REMARKS

This Amendment, submitted in response to the non-final Office Action dated December 8, 2004, is believed to be fully responsive to the points of rejection raised therein. Accordingly, favorable reconsideration on the merits is respectfully requested.

Ser.No.:
 Inventor(s): R. S. Bunker
 Docket No.: 120478
 Attorney: P. Clarke
 Telephone: (518) 387-5349

Fig. 1

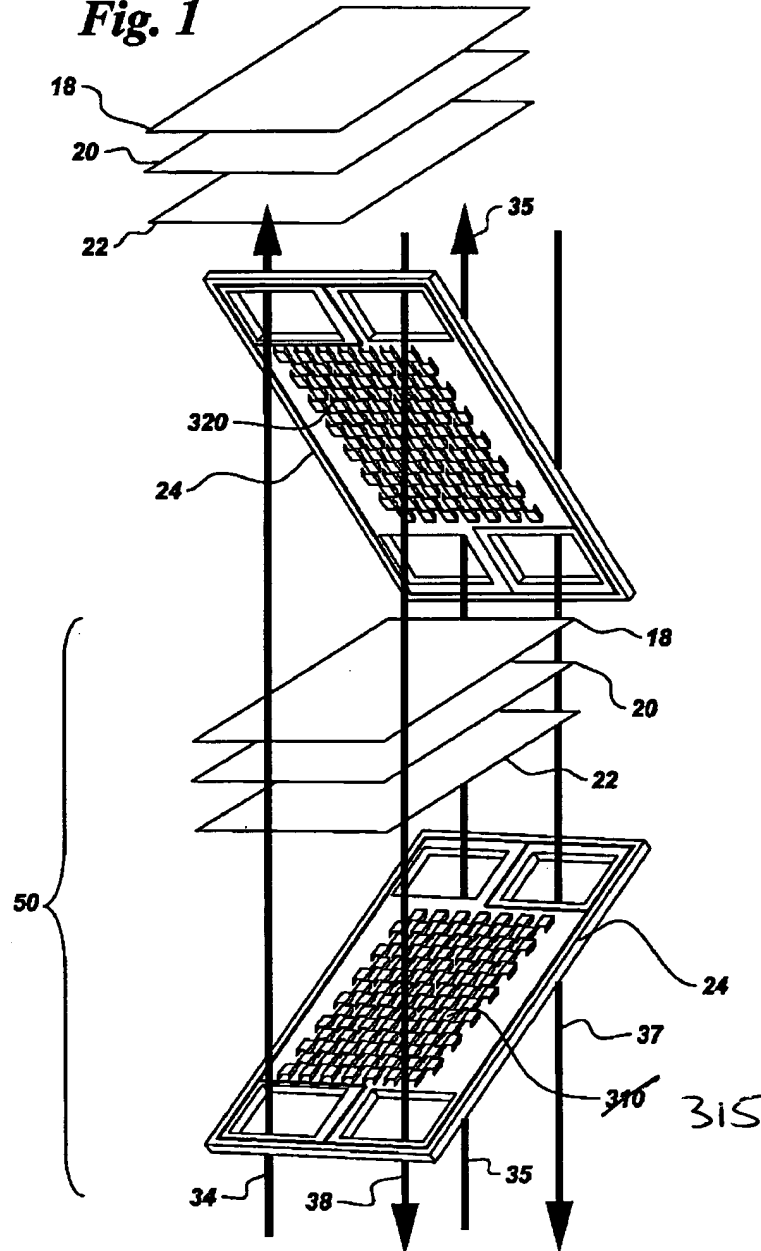
The Examiner objected to FIGS. 1 and 2. As requested by the Examiner, FIGS. 1 and 2 have been labeled as prior art, in that they merely illustrate exemplary internally and externally manifolded fuel cell stacks.

On page 4 of the office action, the Examiner objected to the specification for informalities regarding certain reference numbers. FIG. 1 has been amended to replace reference number 310 with 315, as indicated in Paragraph 22. Paragraph 24 is amended above per the Examiner's suggestion.

Fig. 3

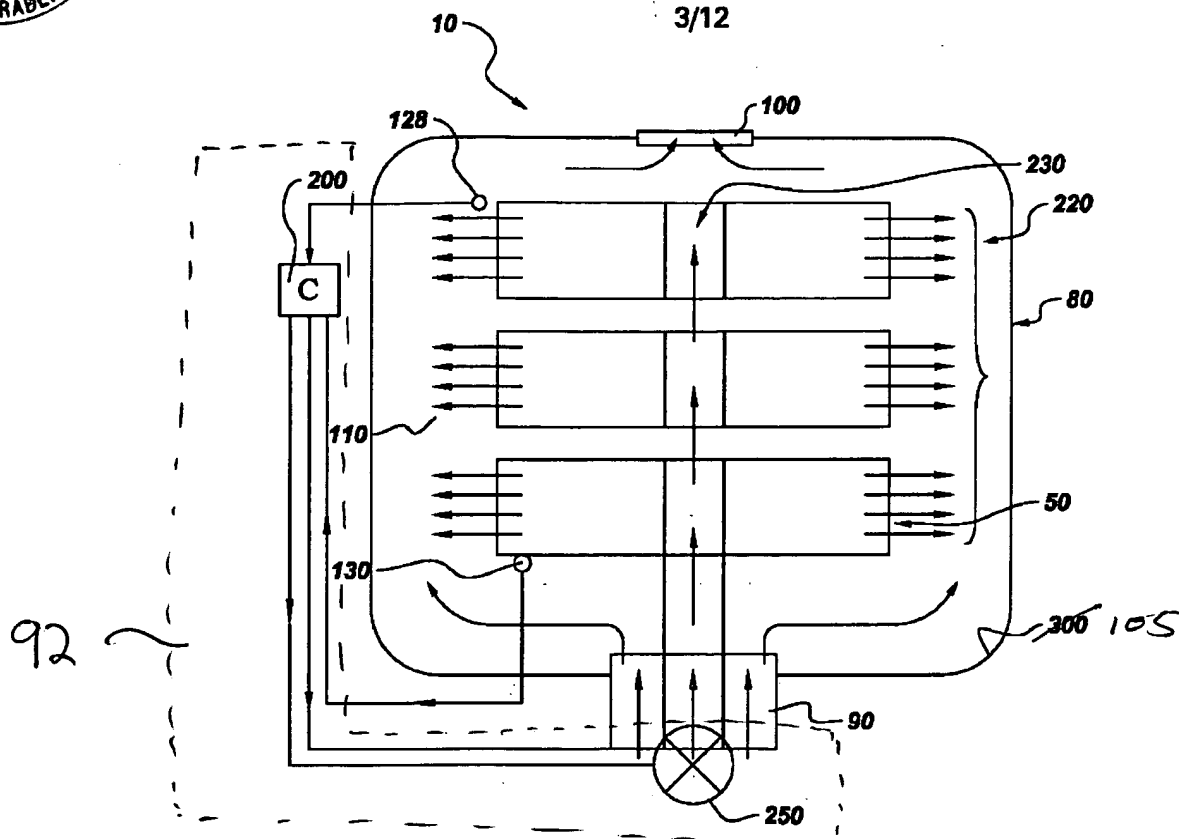
The Examiner objected to FIGS. 3, 5 and 12 for including reference number 300. Reference number 300 has been replaced in FIGS. 3, 5 and 12 by reference number 105. Reference number 105 has also been added to FIG. 6. Support for the amendments can be found, for example, in paragraph 28 on page 7 of the present application. Reference numeral 92 has also been added to FIGS. 3 and 12.

The Examiner objected to the drawings for failing to include reference numbers 105, 113 and 320. As noted above, reference number 105 has been added to FIGS. 3, 5, 6 and 12. Reference number 320 has been added to FIG. 7. Support for this amendment can be found in paragraph 29 on page 8, for example. FIG. 10 has been corrected to replace reference number 100 with reference number 113, to indicate the bypass flow exit of this embodiments, as described in paragraph 28 on page 7 continuing to page 8.

Fig. 6

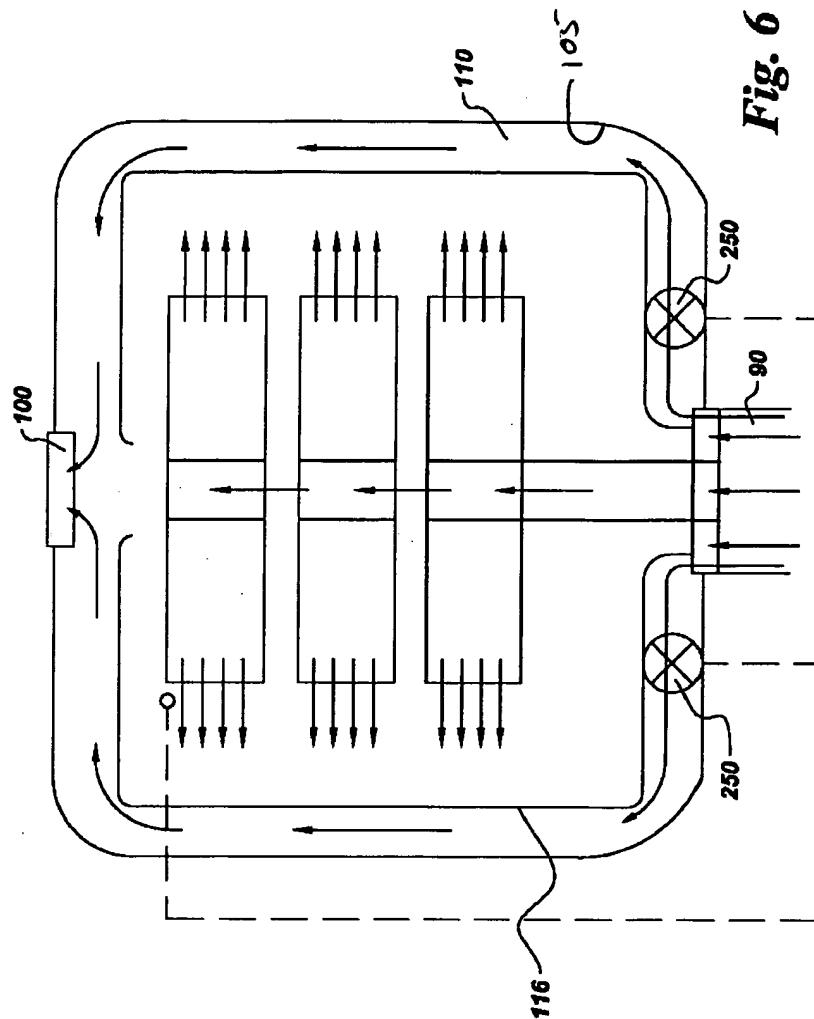
The Examiner objected to FIGS. 6 and 10 for including reference number 250. However, flow regulators 250 are discussed in paragraphs 25 (page 6) through paragraph 27 (page 7) of the present application.

Fig. 12

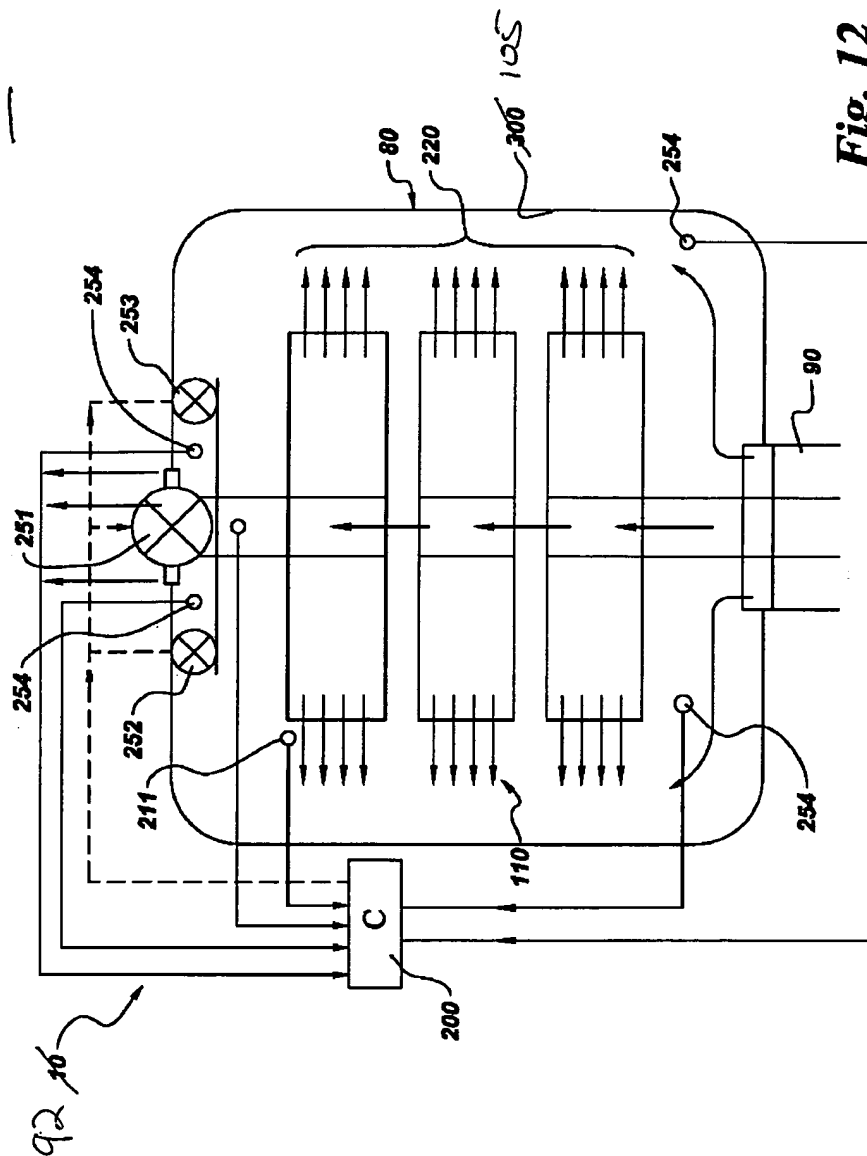
The Examiner objected to the drawings for using reference number 251 to designate both flow regulator and control sensor. Paragraph 31 on page 9 is amended above to replace 251 with 211, as shown in FIG. 12.
